Date: March 10, 2020
To: Planning Board
From: Kellie Shamel, Town Planner
Subject: Frederick & Celia Lorden Trust (owner) and Ponemah Hills, LLC (applicant) – Review for acceptance and consideration of final approval for a major site plan to construct a 6,447 square foot, 9-unit multifamily residential building with a nine stall carport along with associated site improvements. The parcel is located at 0 Ponemah Hill Road in the Residence B District. Tax Map 43, Lot 61.

Ponemah Pines Site Plan

**Re: Ponemah Pines Site Plan, Ponemah Hill Road (Map 43, Lot 61)
Drainage Review**

**Re: Interdepartmental Review Map 43 Lot 61
Ponemah Pines LLC Site Development Plans
19 Ponemah Hill Rd**

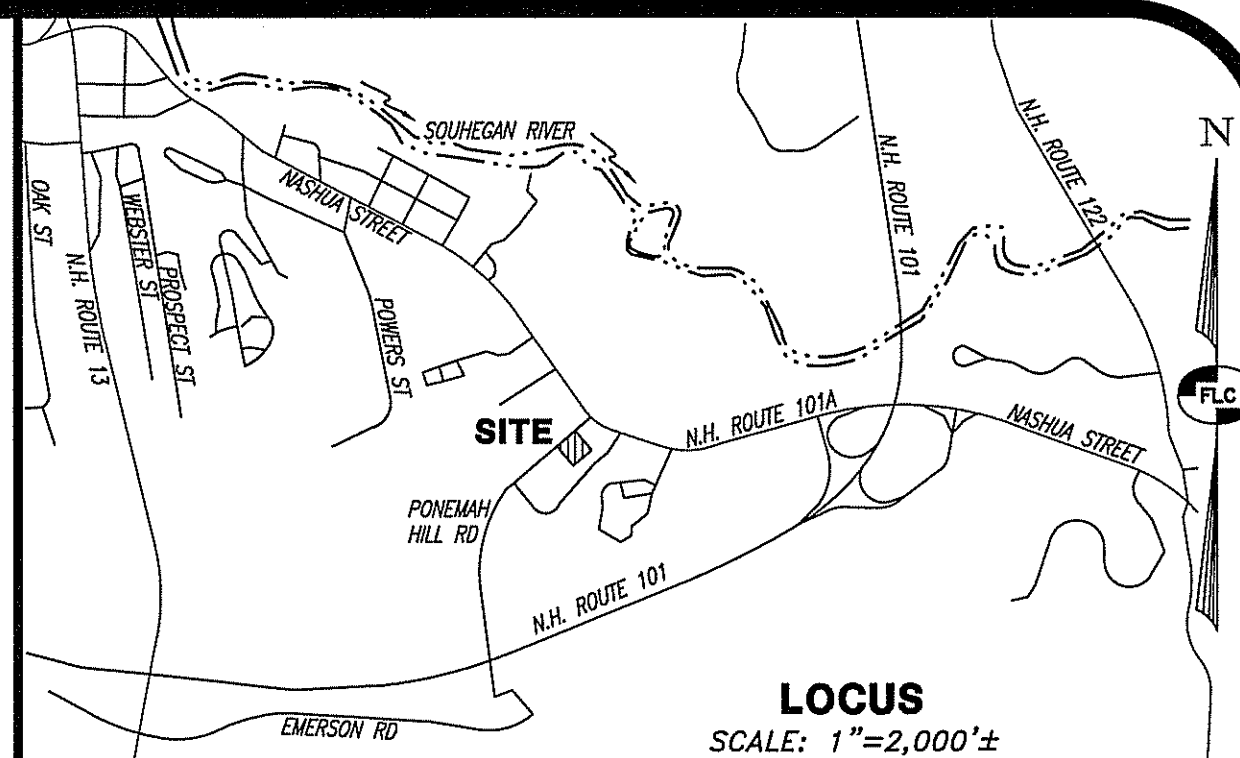
Relative to the boards questions, The requirements are from Saf-C 6000 the NH State Fire Code, NFPA 1 Uniform Fire Code 2015 Edition, Chapter 18, Fire Department Access and Water Supply.

We have 7 or more apartment building with either 360 degree access or access on 2 to 3 sides. This is done for rescue from porches.

The access road width is required by NFPA 1 Uniform Fire Code, Chapter 18, Section 18.2.3.4.1.1.

LIGHTING & LANDSCAPING PLAN

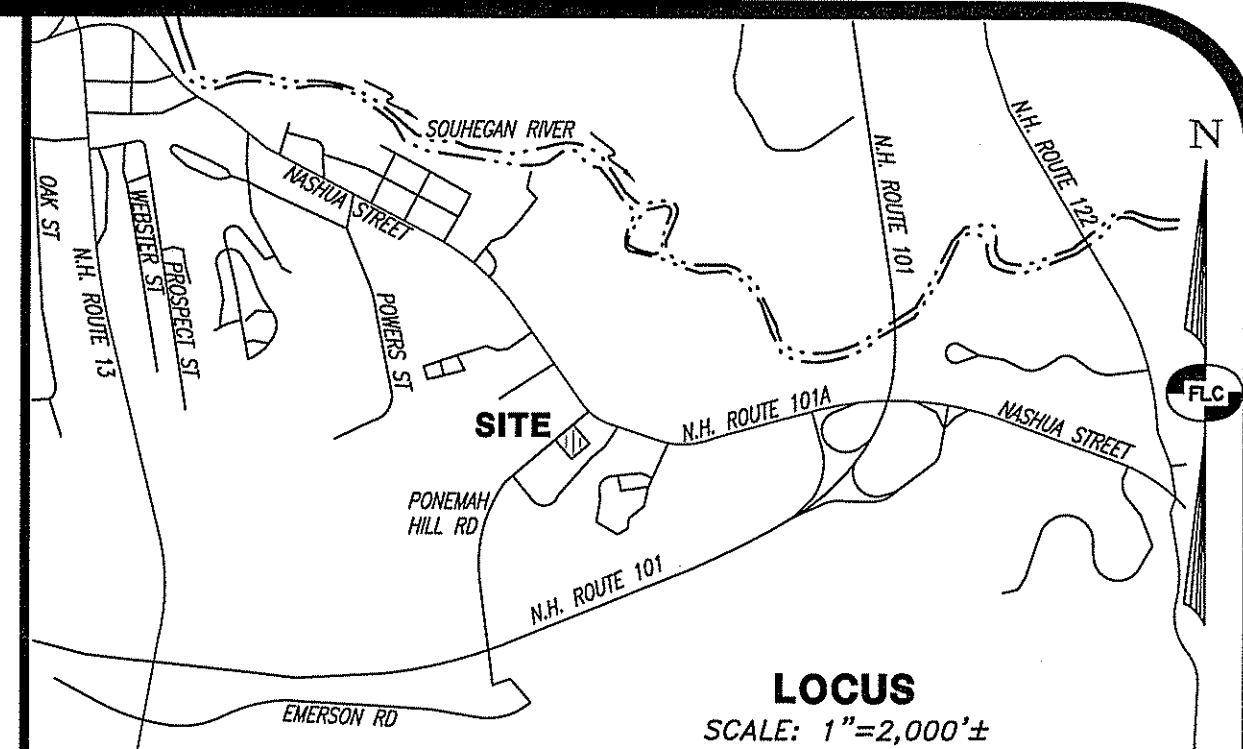
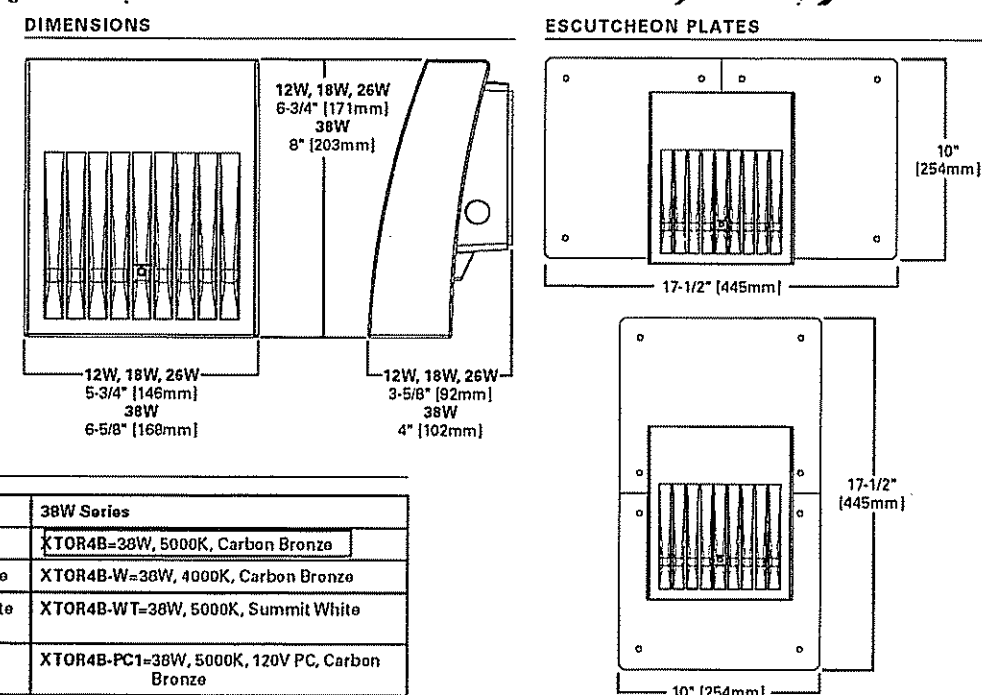
The applicant has revised the landscape plan to include additional plantings along the frontage of Ponemah Hill Road in compliance with Section 6.08.7A.2. Additional plantings (arborvitae) have been added to the eastern buffer area as discussed at the last Planning Board meeting.

Staff would recommend installing additional vegetation buffer in areas where there may be gaps.

3. General Comment. Please confirm the sight distance is adequate. There is concern about sight distance to the west while exiting the site given the curving of the road. *Addressed.*
4. Landscape Plan. Staff would recommend additional tree plantings along the frontage of Ponemah Hill Road in compliance with Section 6.08.7.A.2 requiring one tree per each 30 feet of landscaped strip along the access way (unless it can be shown that existing trees meet these requirements). *Addressed.*
5. Landscape Plan. Staff would recommend additional landscaping within the site in compliance with Section 6.08.6 requiring a minimum of 1 shrub for every 5 feet of building frontage and additional landscaping within the site that is compliant with Section 6.08.7.

1. The Commission members were told that the applicant proposes to use arbor vitae for their buffer plantings. These plantings could be supplemented with columnar junipers which provide winter food for birds and other wildlife. These plants are also quite hardy in challenging soils.
2. It is unclear what the surface material will be for the proposed emergency vehicle access on the north side of the building. Would the applicant consider using geogrid with grass or other hardy groundcover planting? This will promote water infiltration and a more attractive aspect for the homeowners for an access that, hopefully, will be rarely utilized by emergency services.
